UNITED STATES PATENT AND TRADEMARK OFFICE

10/569,317

Office Action Summary	Application No. 10/569,317	Applicant(s) GAN, JIECAI	
	Examiner KAREN YOUNKINS	Art Unit 3751

DETAILED ACTION

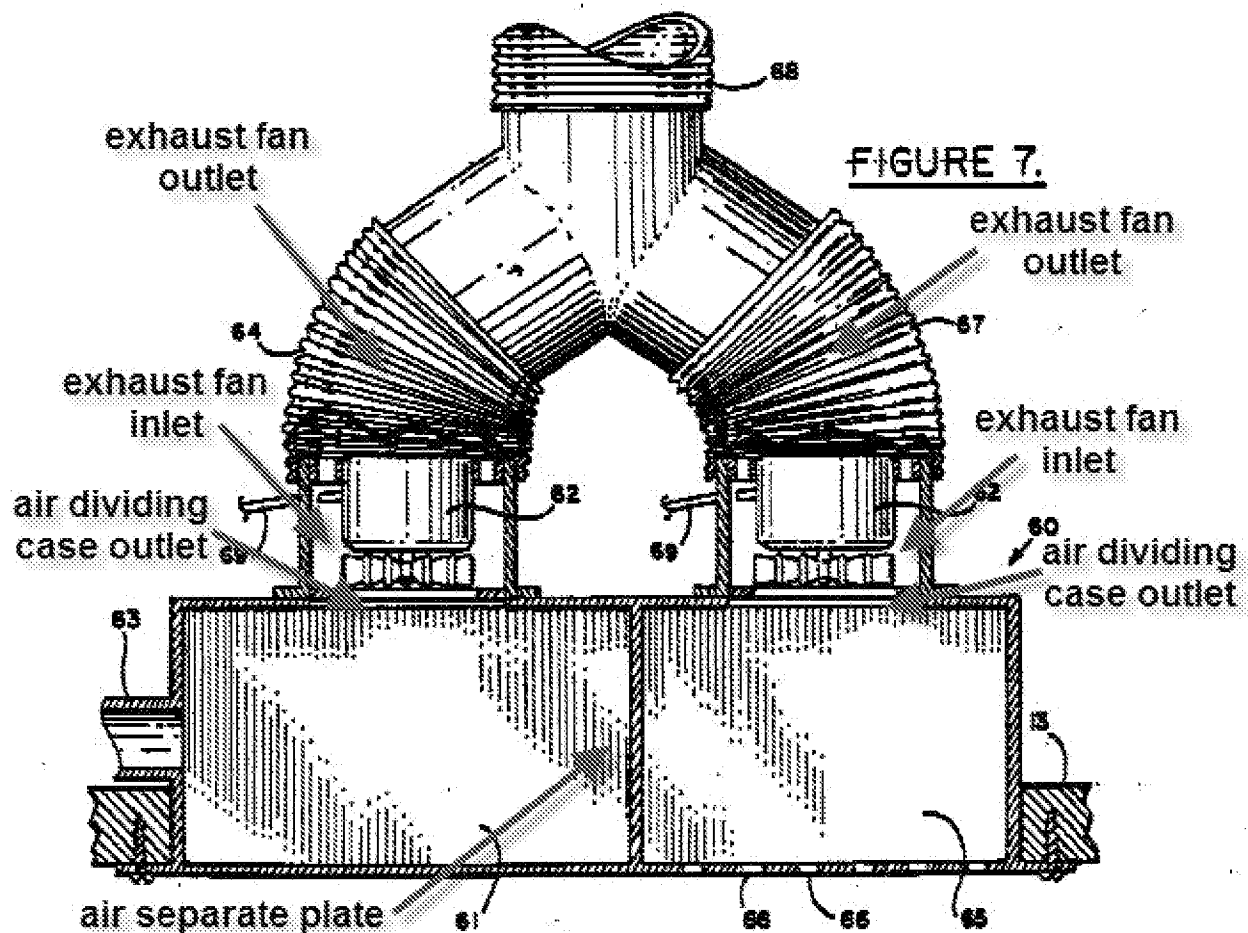
21. Regarding claim 11, Prisco discloses, with attention drawn particularly the embodiment disclosed in figure 7, an exhausting apparatus with an air dividing case (surrounding compartments 61 and 65) for a water closet (10) comprising an air dividing case having an inner chamber (61/65) with an outlet at a top of the air dividing case (see examiner annotated drawing above) and an inlet (via 63) connected with a water closet (see column 4 lines 12-14). The exhausting apparatus also includes an exhaust fan (62) with an outlet and inlet connected with the outlet of said inner chamber (see examiner annotated drawing above) that is fixed on top of the air dividing case as

claimed. The outlet of the exhaust fan is connected, or 'open', to the outdoors through a duct (67), see column 4 lines 16-22. Further, Prisco discloses the inner chamber having through holes via the screened openings 66. The screen/'lid' covering the openings is 'moveable' on and off of the openings. The inner chamber has an 'air separate plate' inside of it, see examiner annotated drawing above. The 'air separate plate' divides the inner chamber into two chambers (61 and 65) such that one chamber (61) leads to the water closet (10). Prisco also discloses the use of the 'air separate plate' dividing the inner chamber into dual compartments may be required in rooms having a plurality of toilets, see column 4 lines 22-24. Further, the outlet is separated by the air separate plate into two parts to the extent claimed, and the apparatus is installed on a ceiling of a room housing a toilet (see figure 1). The apparatus is "open" to the toilet as it is connected to the toilet via the air system.

Prisco fails to show an air valve located between the inner chamber inlet and the inner chamber. Prisco also fails to disclose the second chamber (65) leading to another water closet/toilet.
